Planning Application Consultation Response

Application Number	DM/25/2149
Response Date	28.04.2026
Site Location	Land To R/O Keepers Valebridge Road Burgess Hill West Sussex RH15 0RT
Development Description	Construction of 1 no. house with attached garage and retrospective permission for the creation of a new access from Valebridge Road. (Flood Risk Assessment received 12.01.2026. Arboricultural Method Statement and tree plans received 20.04.2026. Revised description agreed 22.04.2026)
Recommendation¹	Objection

Figure 1: Risk of Flooding from Surface Water present day 2025 (Source: EA)

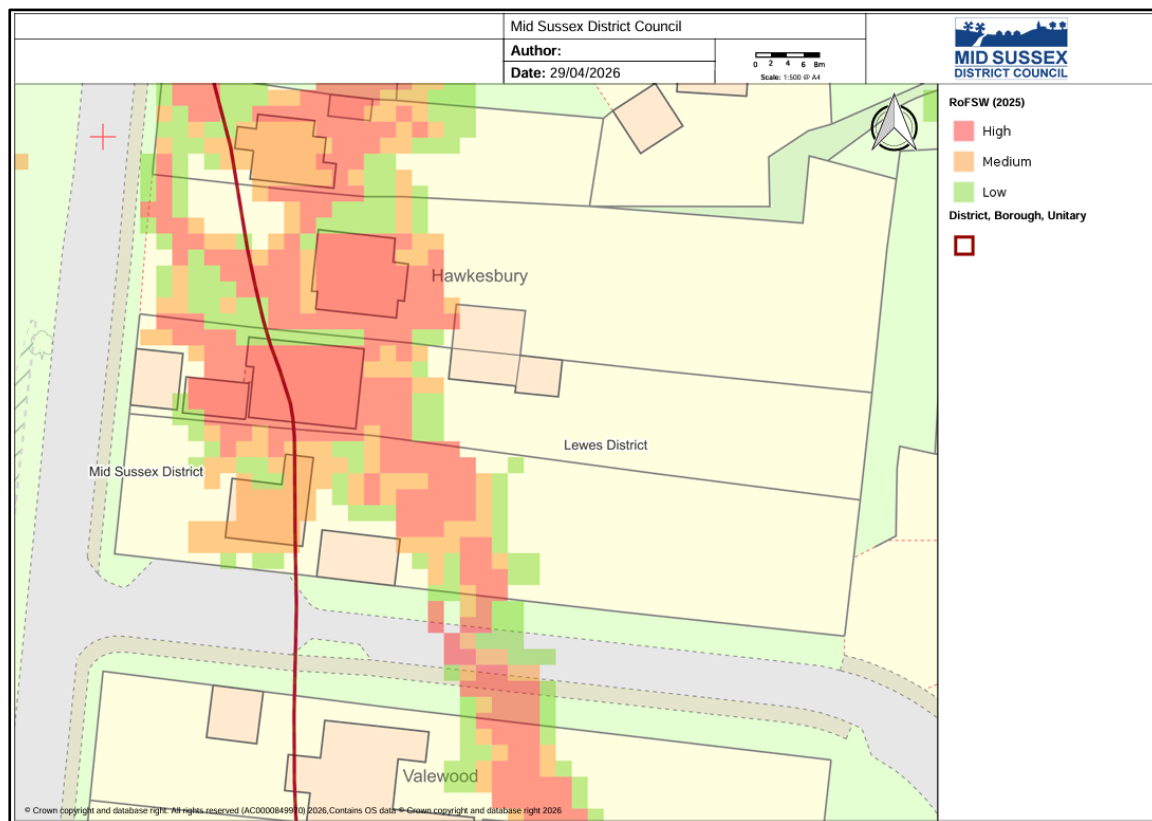
The Risk of Flooding from Surface Water mapping suggests the site is shown to be at “Very Low” to “High” surface water flood risk (comparable to flood zones 1 and 3b) for the present day (2025) and to be at “Very Low” to “High” surface water flood risk (comparable to flood zones 1 and 3b) within the climate change range of 2040 – 2060.

The area of “High” surface water is associated with a flow path which crosses the site from south to north and encroaches onto the driveway.

Figure 2: Risk of Flooding from Surface Water –Climate Change 2040 – 2060 (Source: EA)

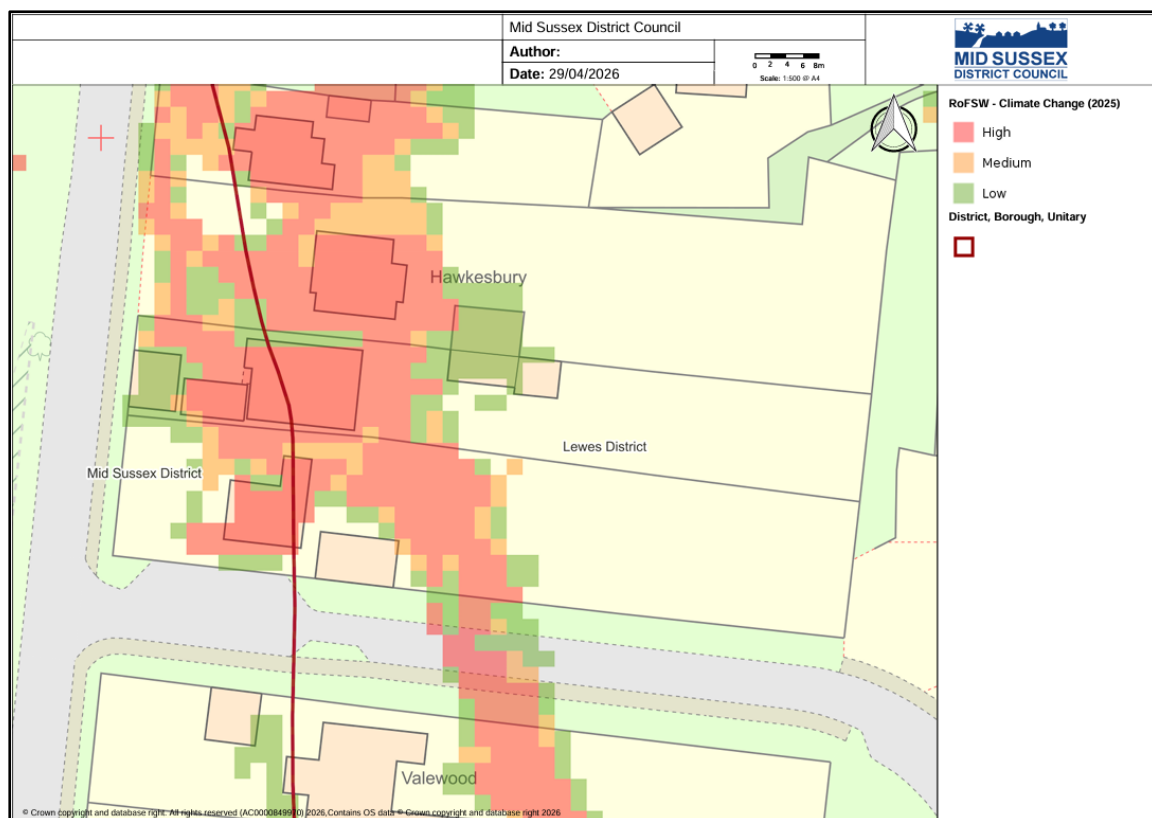
Based on the latest guidance that all sources of flooding should be considered consistently, part of the site would be considered functional floodplain (Flood Zone 3b); it's location part within the 1:30 surface water flood extent with climate change.
